## ATTACHMENT 9.1

# RESPONSE TO AER DRAFT DETERMINATION ON PUBLIC LIGHTING

**Figure 1: Lamp Survival<sup>21</sup>**

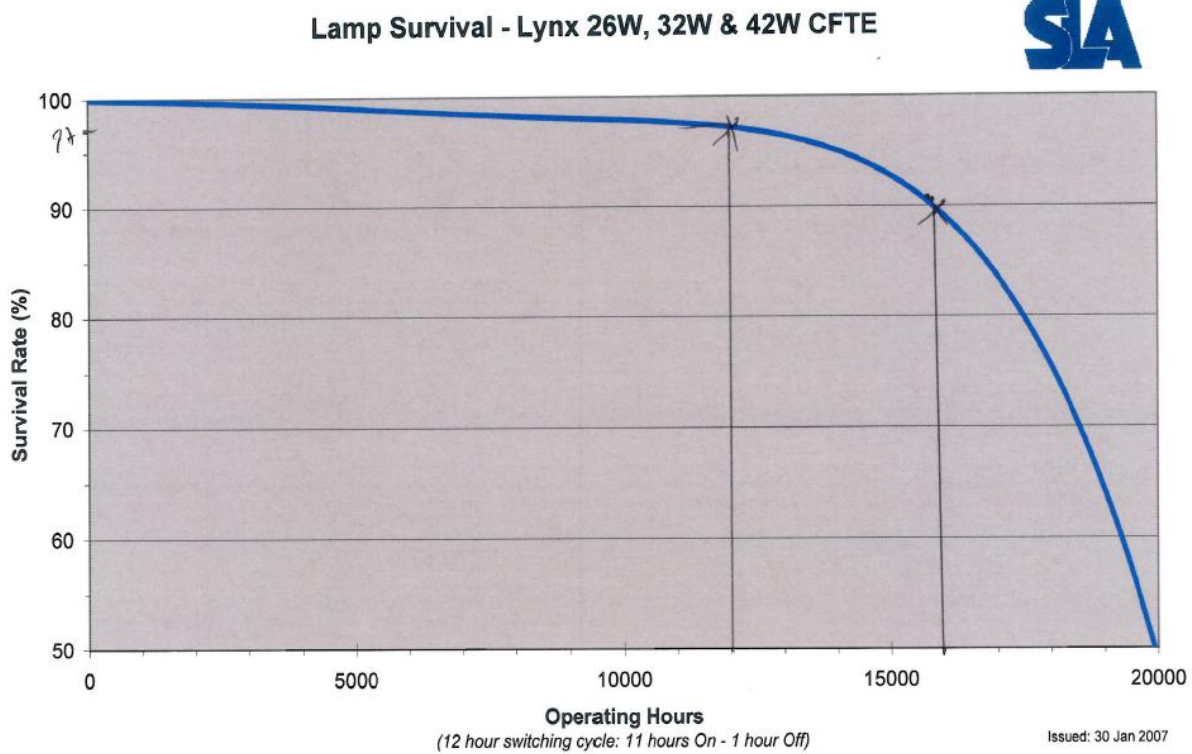
Figure 1 shows the 42W CFL lamp mortality in the first three years is reasonably linear to a survival rate of approximately 97 per cent. In the fourth year of operation, the survival rate drops from 97 per cent to 90 per cent. In order to determine the impact of the four year bulk lamp replacement cycle, Essential Energy has recalibrated the historical failure rates by technology as follows:

Figure 4: Impact of outsourcing on direct and overhead cost categorisation

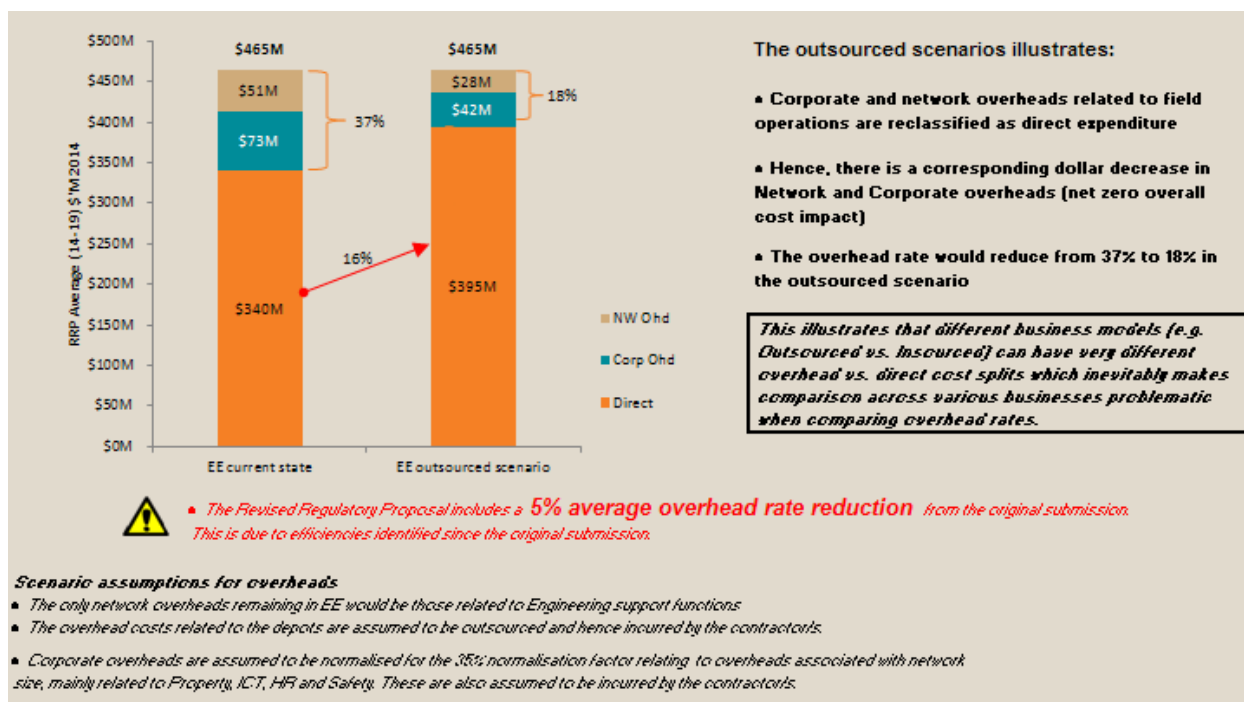
In Figure 4, Essential Energy has modelled a scenario to illustrate the impact of different blended service delivery models on overhead rates. The scenario assumes a business model that mainly outsources its network operations. The rationale being that if the work was outsourced, Essential Energy would not incur the level of overhead it currently recognises through its current costs categorisation. The outsourced functions would be invoiced to Essential Energy by the contractor and the invoice amount would be loaded with both an element of corporate and network overhead. This split would not be visible on the invoice and the whole invoice would be processed as a direct cost.

This transfer of overhead to an effective direct cost increases the direct cost pool while reducing the overhead pool and thus has a compounding effect on the overhead rate (as the direct costs in the denominator increase and the overhead costs in the numerator decrease - hence the overhead rate reduces).
